CONVAIR

COMMERCIAL CHANGE PROPOSAL

SPEC NO.: ZD-22-327

CUSTOMER: JAL

Page 50a - PITOT STATIC SYSTEM - ILLUSTRATION:

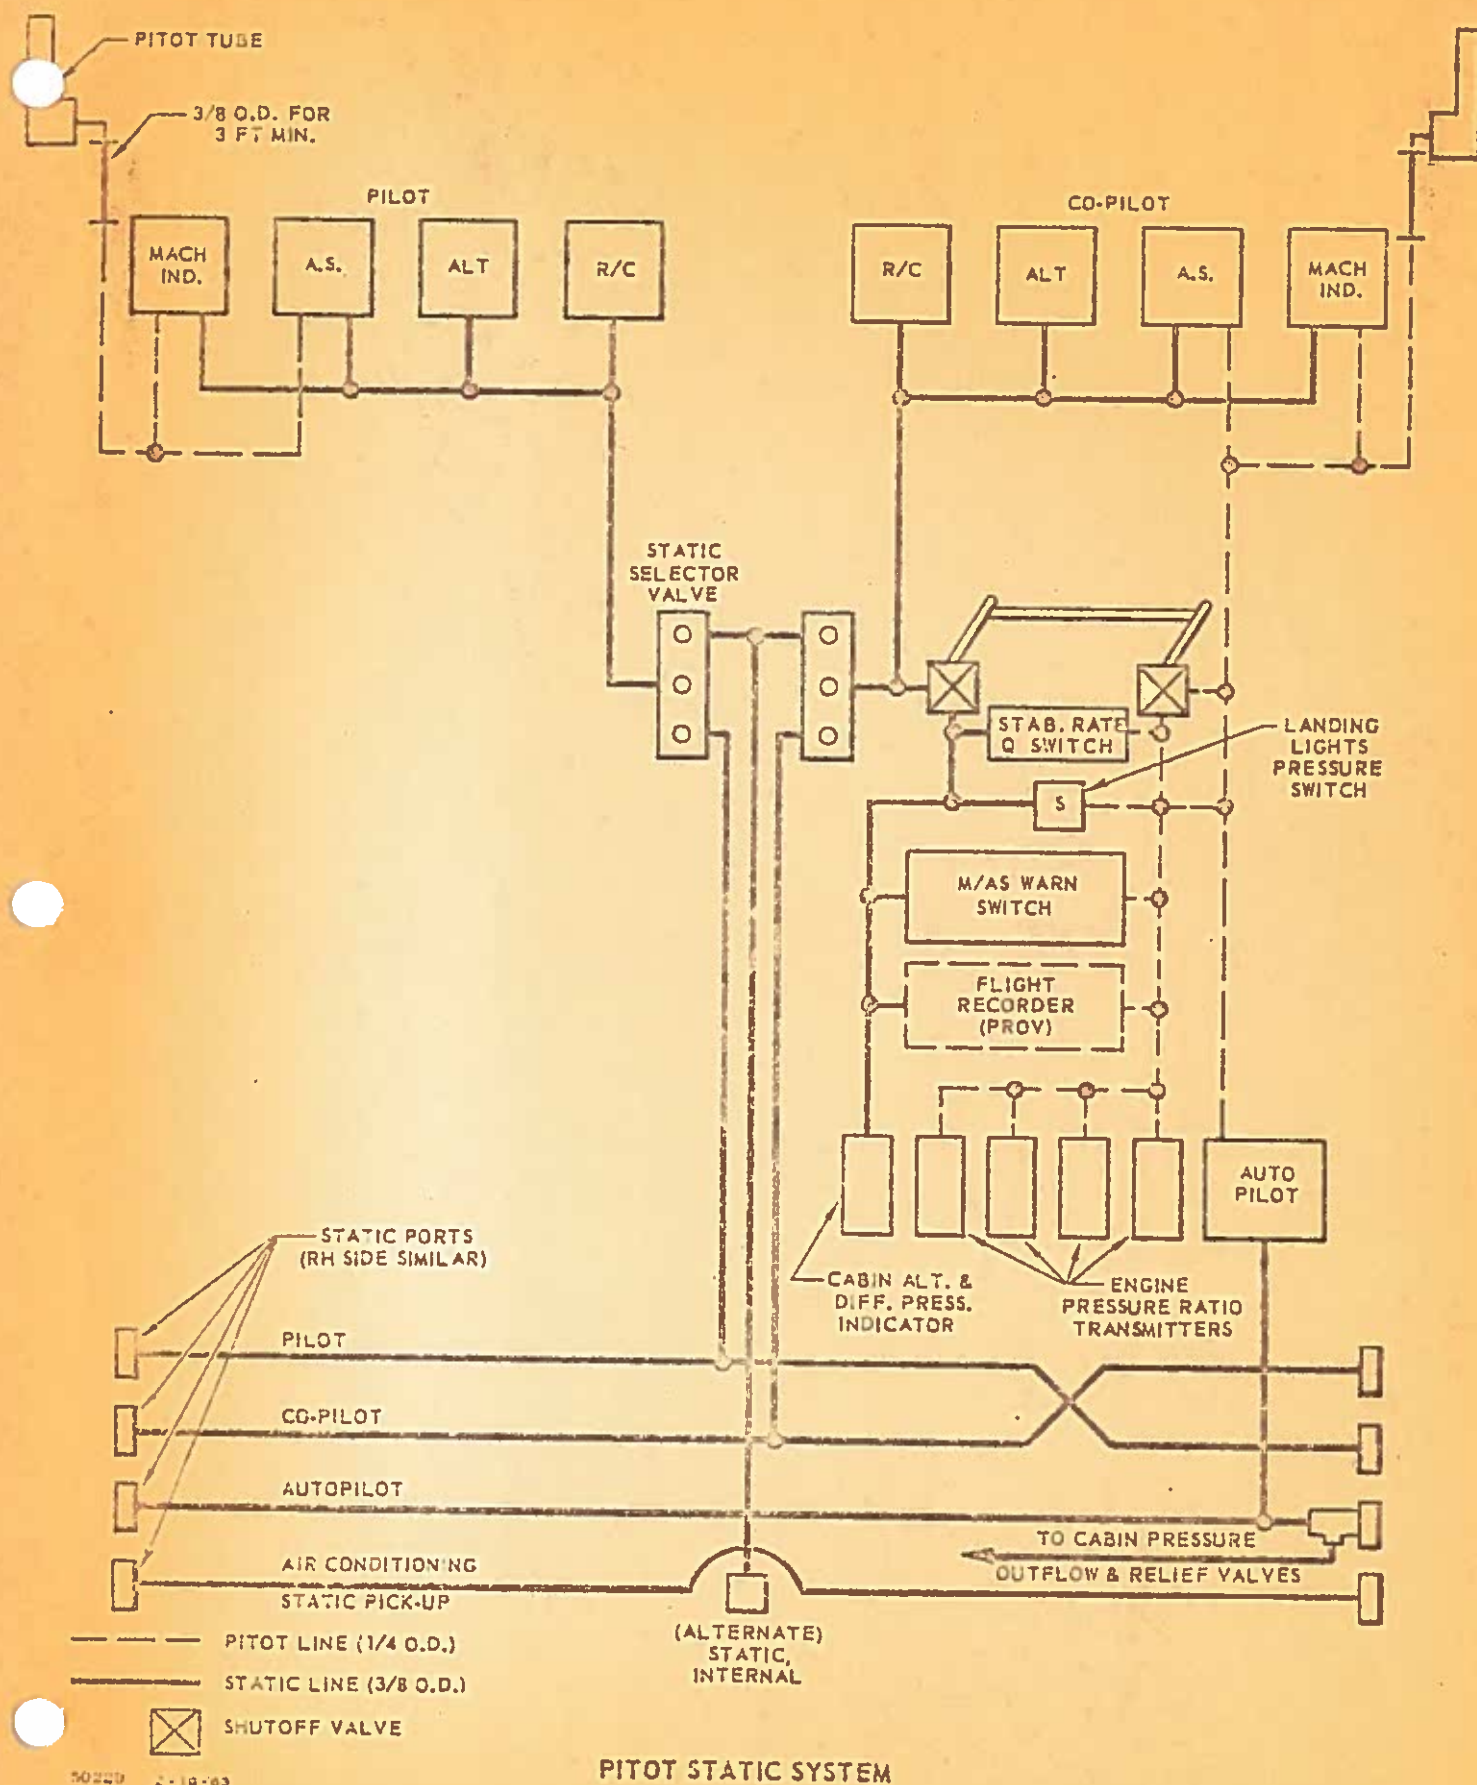
Reason for Change: To up-date pitot static system to show separation of static sources for cabin outflow valves and cabin controller.

Replace above illustration in the specification with attached revised illustration to show current changes.

Page 46a - PITOT STATIC SYSTEM - ILLUSTRATION:

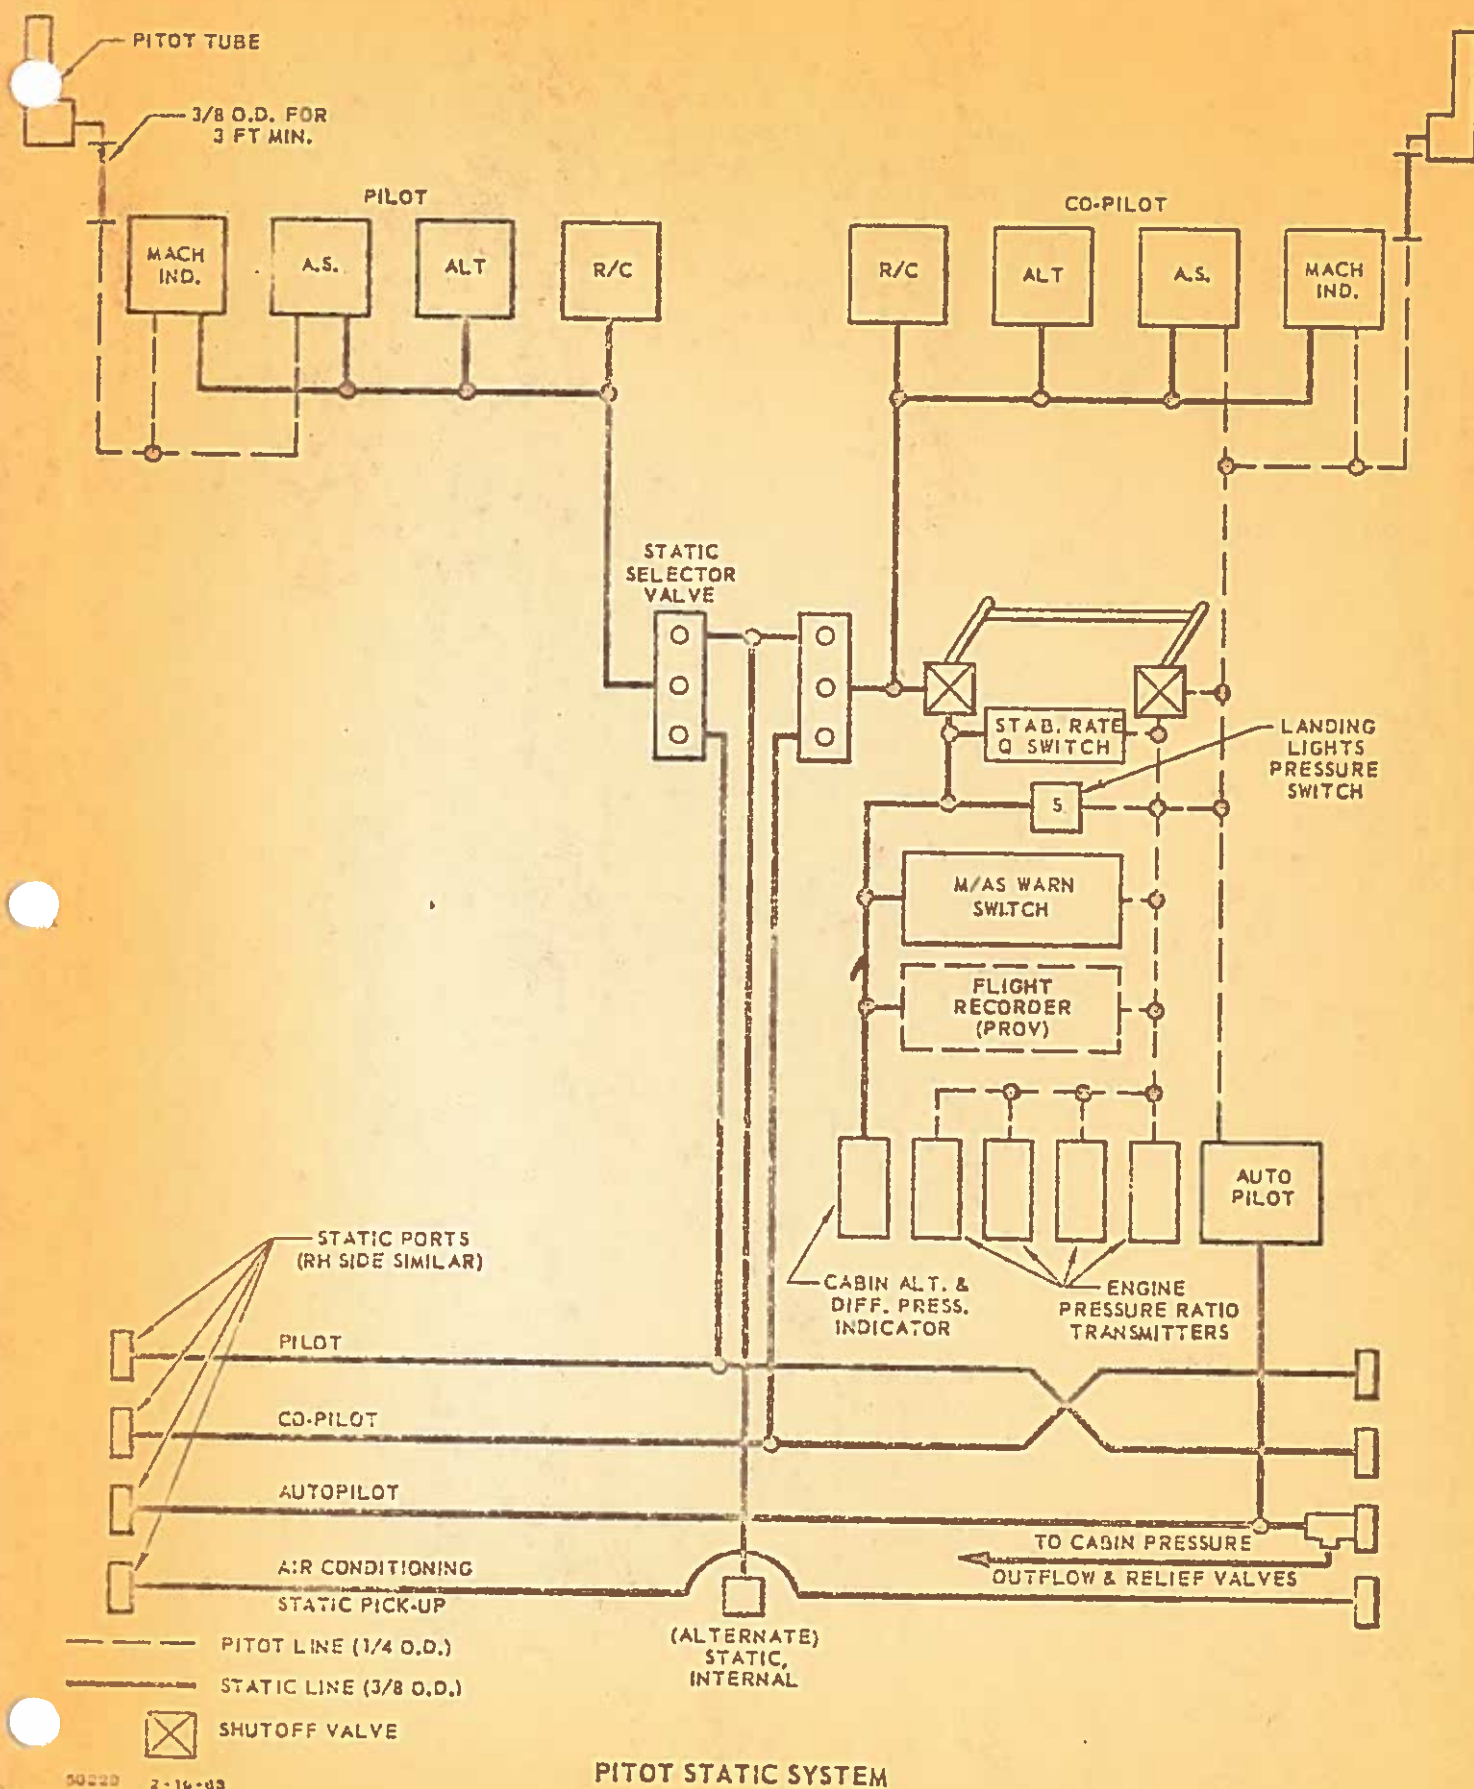
Reason for Change: To up-date pitot static system to show separation of static sources for cabin outflow valves and cabin controller.

Replace above illustration in the specification with attached revised illustration to show current changes.
